# SERVICE BULLETIN

SB1365

<b>ADDRESSEES</b>	: Owners and operators of coaches mentioned under "Application"
<b>VEHICLE MODEL</b>	: C2045, CX35, CX45, TX45
<b>MANUAL CHAPTER</b>	: 02.22 Traction engine – Air intake system
<b>BULLETIN TYPE</b>	: Field Change Program
<b>DATE</b>	: June 17th, 2016
<b>SUBJECT</b>	: To check engine air-intake pipe for interference damage
<b>TERMS &amp; CONDITIONS</b>	: Refer to the warranty section further in this Bulletin.

**Figure 1**

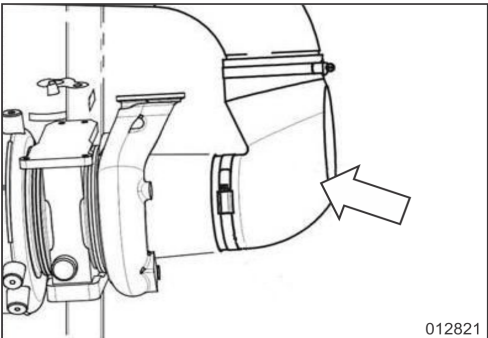
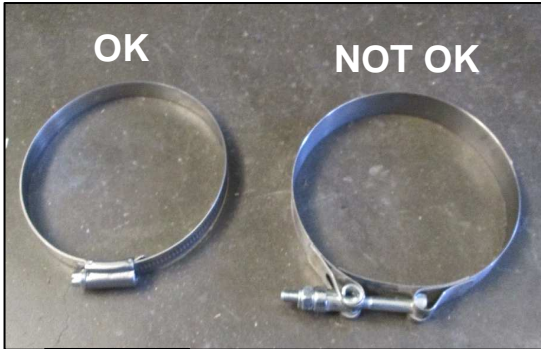
On the vehicles affected by this bulletin there is a possibility of interference between the engine air-intake pipe and a side access panel. This could damage the air-intake pipe over time allowing unfiltered air to enter the engine. This Service Bulletin gives step-by-step instructions to check, and if necessary, solve the problem.

<b>Step</b>	<b>Action</b>
<b>1</b>	<p>Open the exterior access door of the radiator compartment, located on the left very rear side. Remove the screws and take the side panel away to get access to the air-intake pipe between the air-cleaner and the turbocharger.</p> <div data-bbox="568 1563 1182 1982"></div> <p>012827</p>

2	<p>Are there any signs of damage on the air-intake pipe?</p> <ul style="list-style-type: none"> <li>• If so, go to step 3.</li> <li>• If not, go to step 4.</li> </ul>  <p style="text-align: right;"><b>Figure 2</b></p>
3	<p>Is the damage deeper than 1.3 mm (0.05 inch)?</p> <ul style="list-style-type: none"> <li>• If not, reposition the elbow hose at the turbocharger to prevent interference afterwards. Follow the steps as described under "STEP 3A IN DETAIL".</li> <li>• If so, change the air-intake pipe as described under "STEP 3B IN DETAIL".</li> </ul>
4	<p>Flatten the raised edge of the retaining plate of the side panel with a hammer.</p>  <p style="text-align: right;"><b>Figure 3</b></p>
5	Check the air-intake system for leaks when tubing has been removed.
6	Reinstall the side panel.
7	Close the access door of the radiator compartment.
